Access Compliance Report Public Rights-of-Way (Curb Ramps)

Main Street: KATELLA AVE **Cross Street: MAC ST** Location: NW

ADA ID: RPRK210921142303 Ramp Type: Type 4 - Parallel **Initial Pass/Fail: Pass Overall Compliance: No Severity Score:**

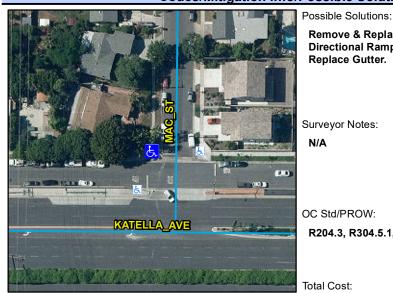
Remove & Replace Curb Ramp With Two New Directional Ramps or Equivalent. Remove &

Replace Gutter.

R204.3, R304.5.1, R304.5.3, STD 1115
